service bulletin

No. 94-10

Power Trim Shaft Not Engaging Sender - 75 thru 125

Mariner and Mercury

Figure 1. 99625--1 Pivot Shaft.

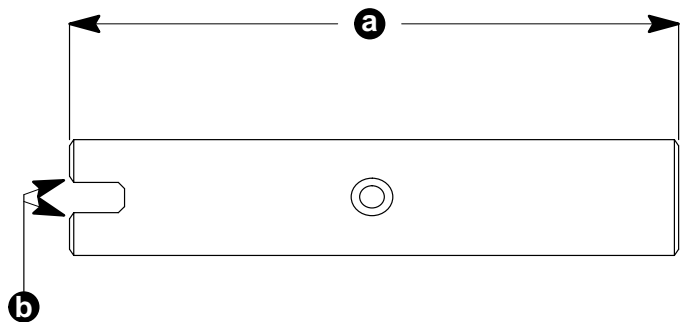
The power trim upper slotted pivot shaft may not totally engage the power trim gauge sender. The trim gauge may operate for a period of time and then quit.

The new pivot shaft p/n 99625--1 is installed on late 1994 75 thru 125 models beginning after the serial numbers listed and supersedes the previous pivot shaft p/n 99625. The new shaft is slightly longer and does not have the chamfer at the outer end of the slot.

a - Slightly Longer.

b - Chamfer Removed.

If the pivot shaft does not engage the sender, install the new slotted pivot shaft p/n 99625--1.

Figure 2. Shim Washer Location.

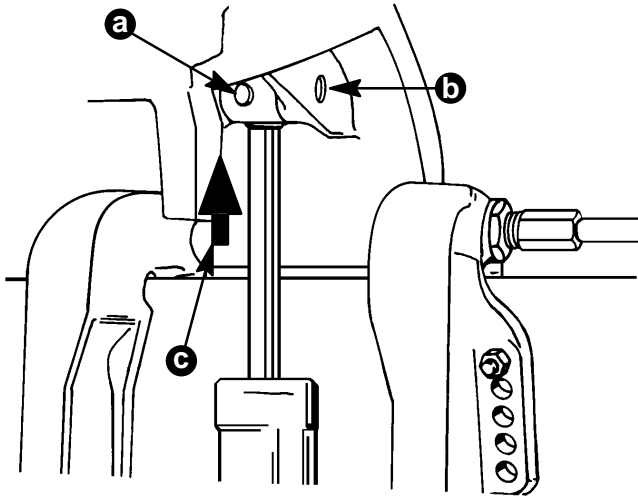
In an emergency, shim the power trim rod eye over toward the starboard side using the washers listed.

Remove the cross pin and the upper pivot shaft. Install 0.125 inch (3 mm) washer(s) listed between the port side of the power trim rod eye and the swivel bracket. Reinstall the upper pivot shaft and the cross pin.

Qty. 1 12-846378
.690 X 1.00 X .120 inch
Stainless Steel Washer
(Shipped from Hi-Performance)

Qty. 4 12-48526
.630 X 1.00 X .031 inch
Nylon Washer

Qty. 4 12-815952
.640 X 1.00 X .031 inch
Stainless Steel Washer

- a - Cross Pin.
- b - Upper Pivot Shaft.
- c - Install Washer(s).
